SUBJECT: License STC-133 response to NRC comments on DNCS/DLA document
 "PRELIMINARY SITE-SPECIFIC DERIVED CONCENTRATION
 GUIDELINE LEVELS FOR THE CURTIS BAY DEPOT, CURTIS BAY,
 MARYLAND", CONTROL NO. 138458

**RESPONSE TO NRC COMMENT SET ONE ON DNSC/DLA DOCUMENT
“PRELIMINARY SITE-SPECIFIC DERIVED CONCENTRATION GUIDELINE
LEVELS FOR THE CURTIS BAY DEPOT, CURTIS BAY, MARYLAND”,
CONTROL NO. 138458**

**RESPONSE TO NRC COMMENT SET TWO ON DNSC/DLA DOCUMENT
“PRELIMINARY SITE-SPECIFIC DERIVED CONCENTRATION GUIDELINE
LEVELS FOR THE CURTIS BAY DEPOT, CURTIS BAY, MARYLAND”,
CONTROL NO. 138458**

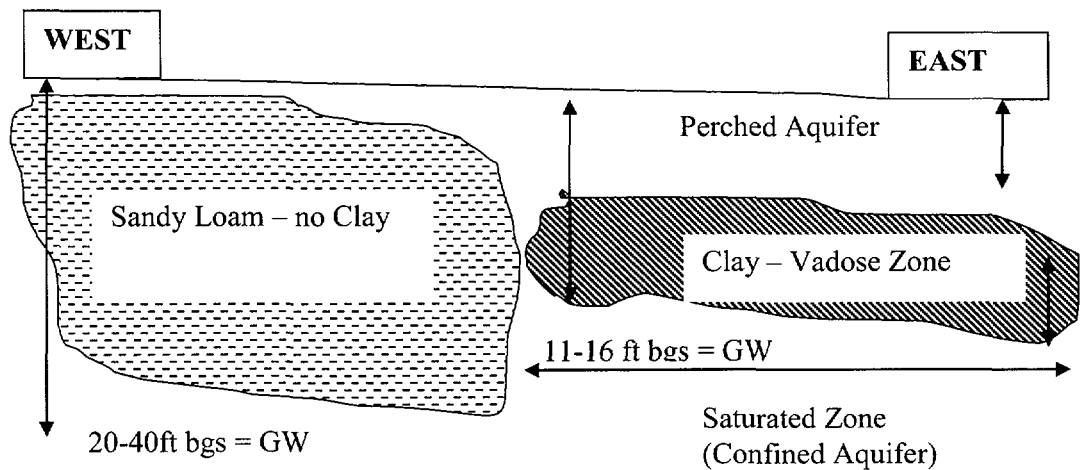
5. **Comment:** Clarify the hydrogeologic conceptual model for the site.

Action: Provide additional information regarding the lateral extent of the clay layer, the hydrostratigraphy, and the range in the depth to groundwater at the Curtis Bay site which is needed to determine an appropriate vertical discretization for the contaminated and unsaturated zones in the RESRAD modeling. If this information is unknown, the uncertainty in these parameter values should be evaluated and justification for the parameter values chosen should be provided.

DNCS Response: The basis for the NRC comment notes a discrepancy between the site model described in the text on page 29 and the parameter values listed in Appendix B. DNCS acknowledges the discrepancy, and will ensure consistent parameter values in the revision of the dose modeling report. The original discrepancy resulted from the sensitivity analysis process, when the last modeled parameter values were saved into the RESRAD file. However, as discussed below, the inconsistency between parameter values and the text description had no measurable effect on the preliminary DCGL values.

The lateral extent of the clay layer from the east side extending into the west side is not understood in great detail. The soil profile is based on a small number of monitoring wells, from which generalizations about the overall site geology are drawn. The geology can best be described as an east to west differentiation trend as shown in the diagram.

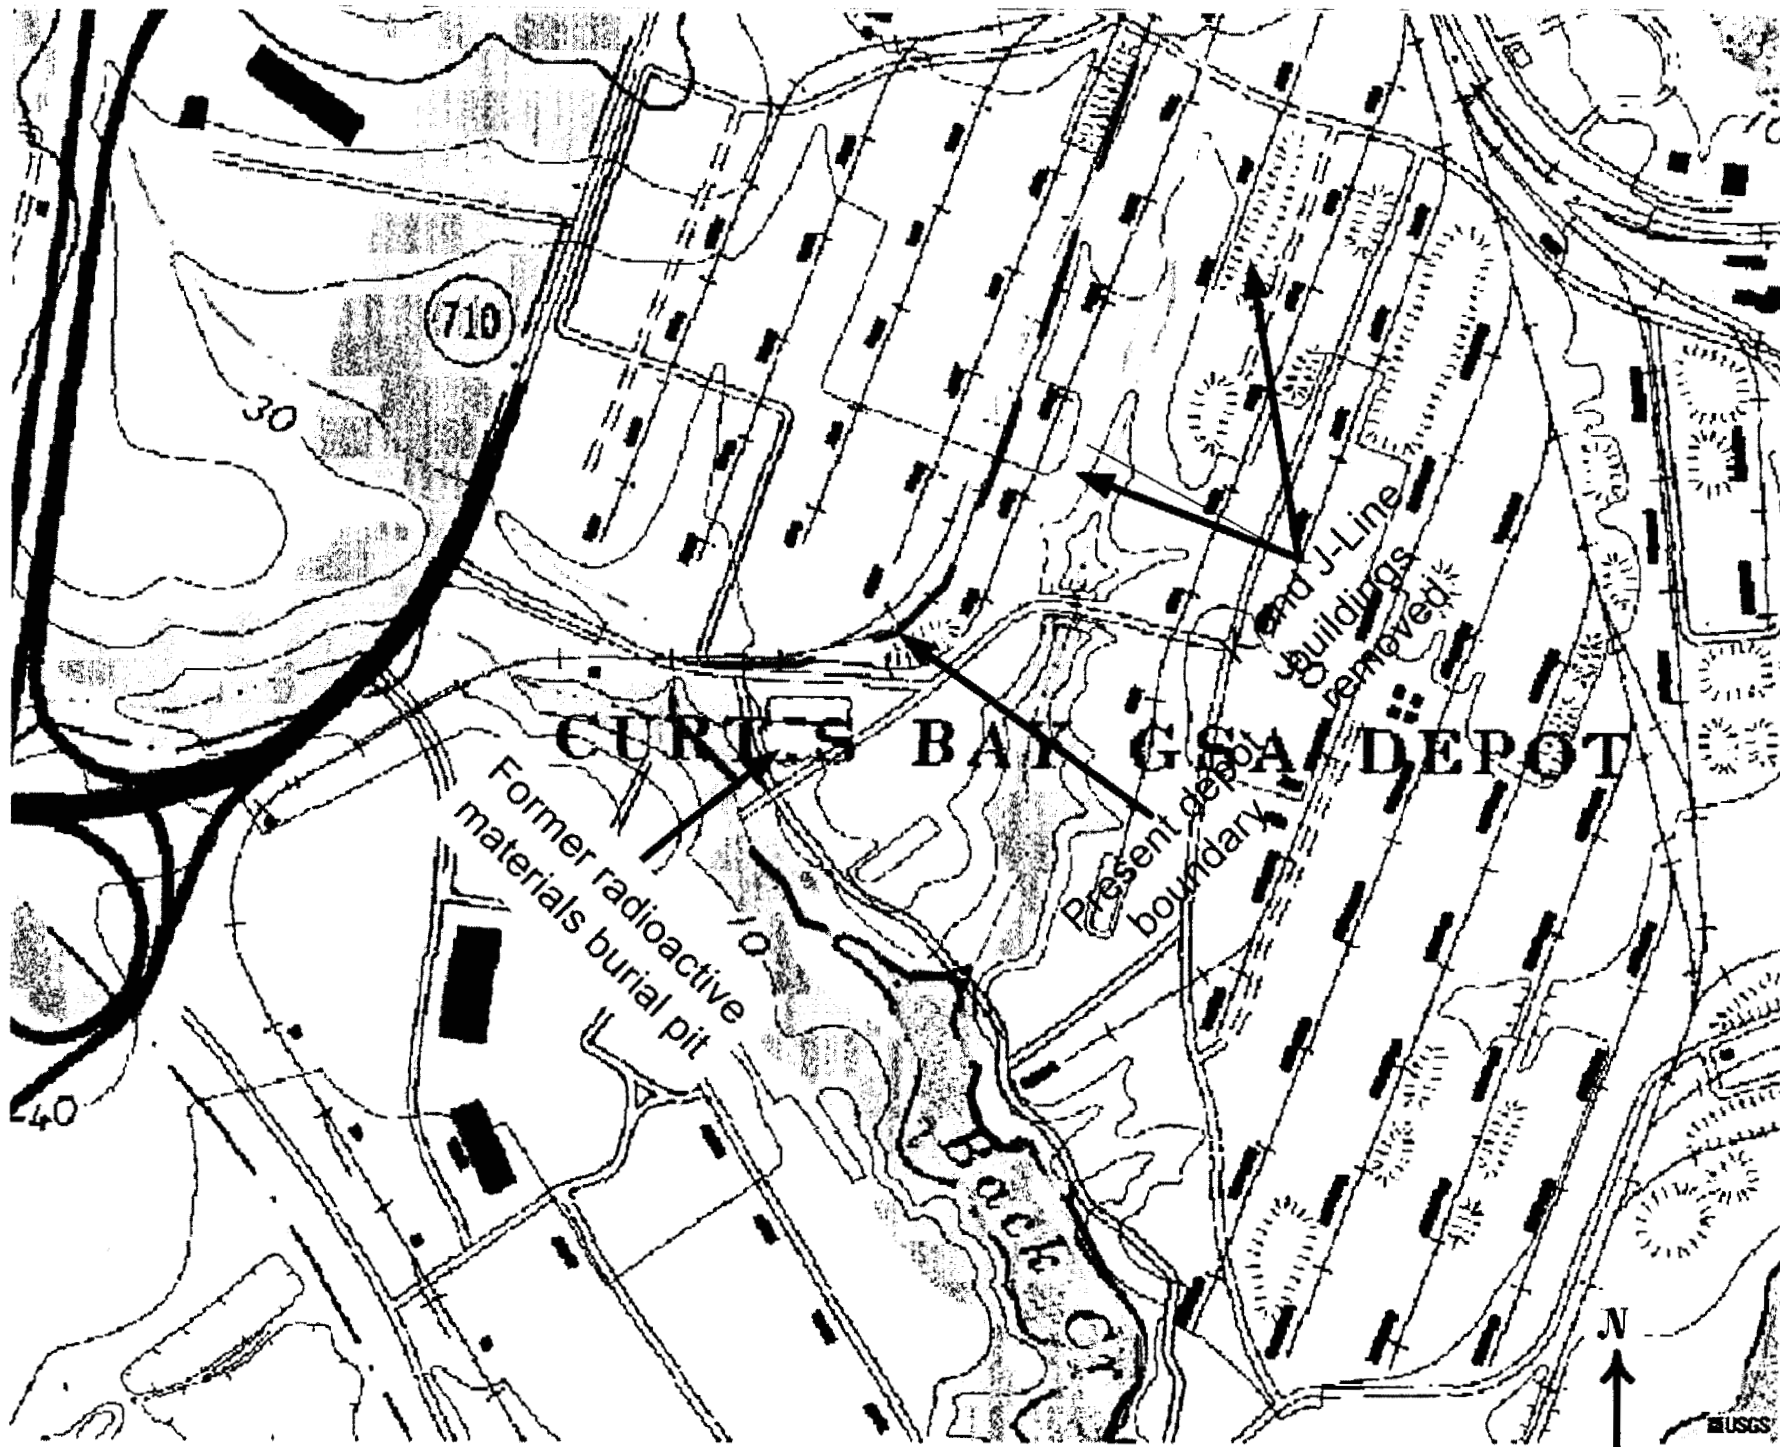
8. **Comment:** DLA/DNSC did not differentiate between or discuss the potential exposure pathways for deconstructed building materials, e.g., concrete pads and debris piles, compared to residual contamination associated with buildings and/or soil contamination.

Action: Provide additional information regarding the final disposition of building materials and debris for the Curtis Bay site. If building materials will remain on-site, you need to consider development of site-specific DCGLs for these building materials and/or demonstrate why other site-specific DCGLs are bounding. Also, provide additional information regarding the potential for migration and transfer of residual contamination from degraded building materials to nearby surface soils and sediments at the Curtis Bay site.

DNSC Response: The deconstructed building materials will remain on site. The buildings in question were not surveyed while intact due to safety considerations. Note that none of the deconstructed buildings were classified as Class 1, and all have very low potential for contamination. After deconstruction, the material was surveyed, and no contamination was found. Surveys included surface scans of up to 50% of the staged material and direct surface activity measurements. Survey results will be provided in the ORISE characterization survey report.

USGS Quad Map—4 km NE of Ferndale, Maryland (7/1/1974)

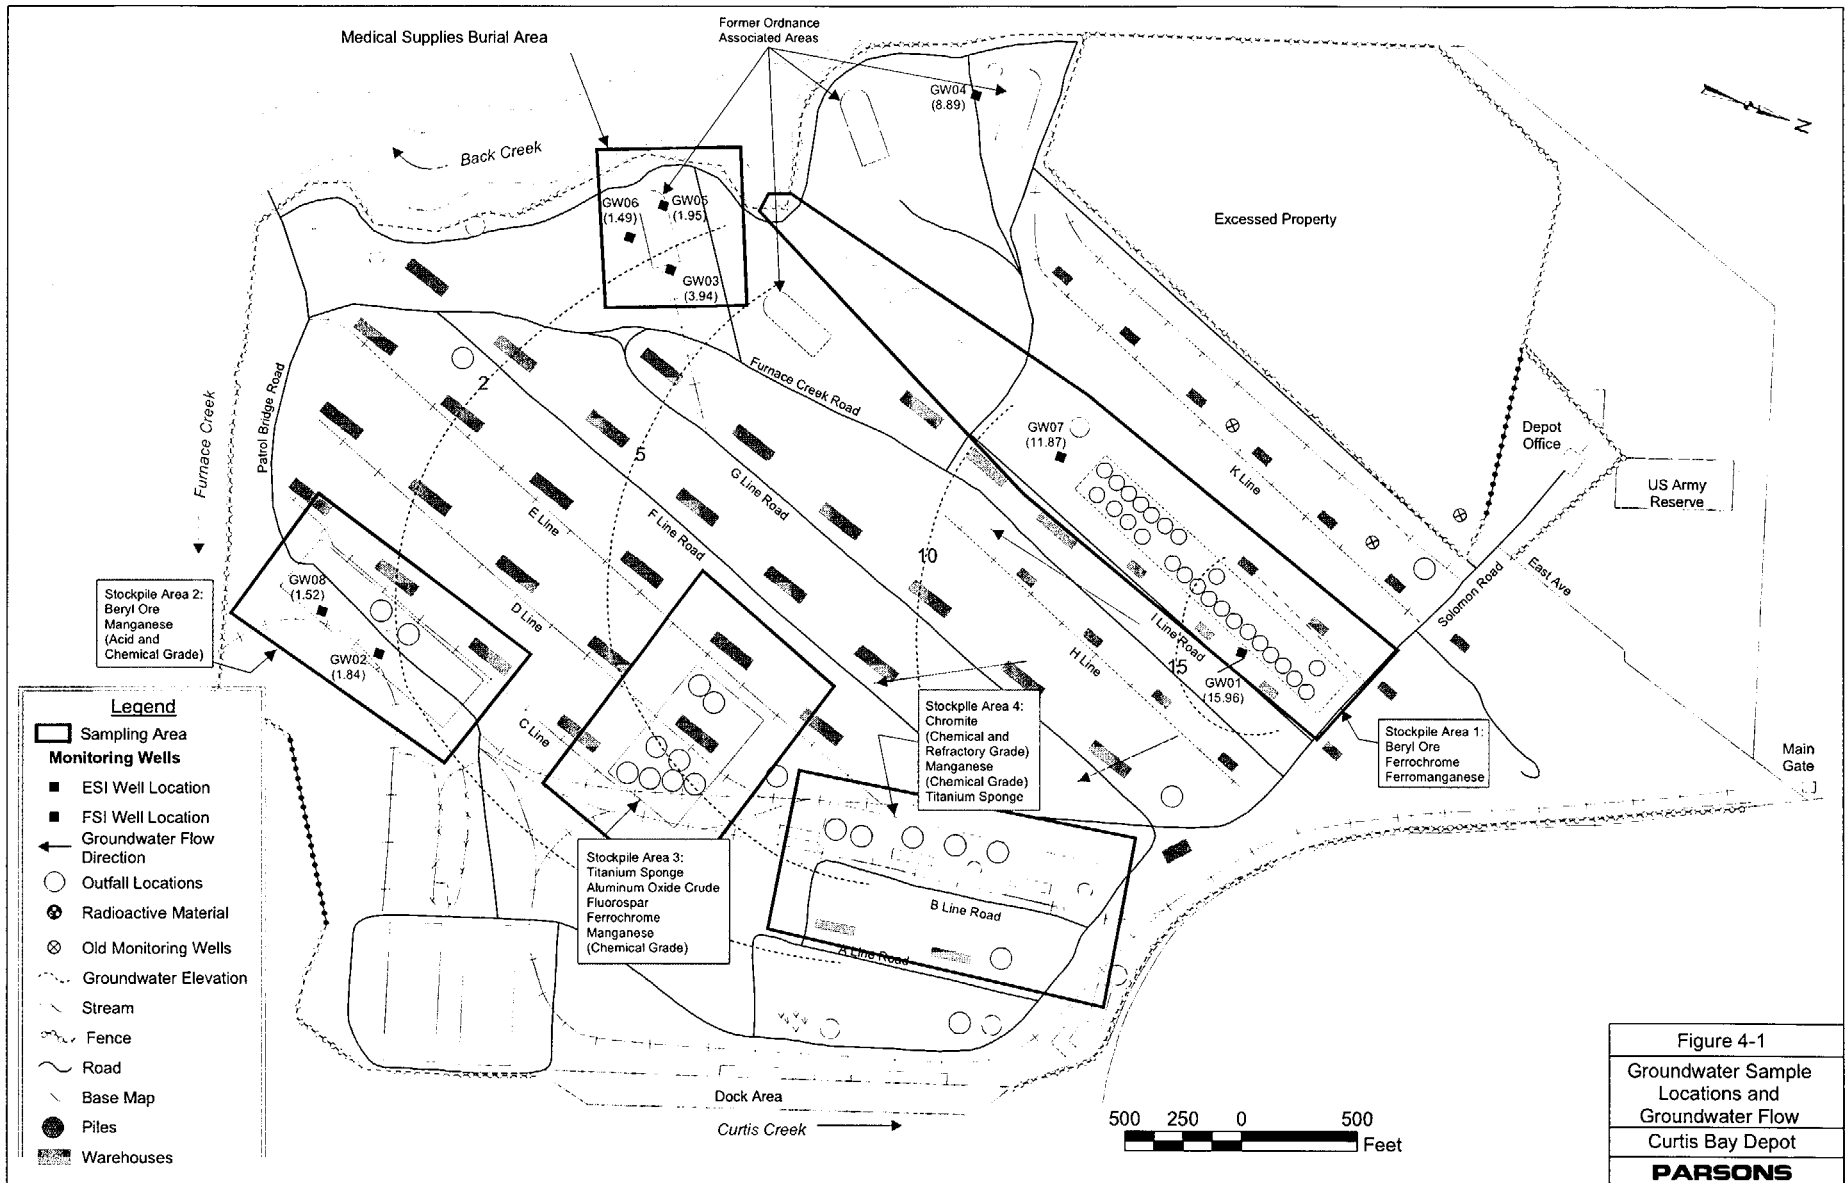
1. **Comment:** Submit a map that shows the detailed topography of the site using contour interval as described in NUREG 1757, Volume 1, Rev. 1, “Consolidated NMSS Decommissioning Guidance – Decommissioning Process for Materials Licenses”, section 16.3.1.

DNSC Response: A topographical map of the Curtis Bay Depot site is enclosed with this response. DNSC is providing the best available map, however the contour details are limited due to the relatively flat landscape of the area.
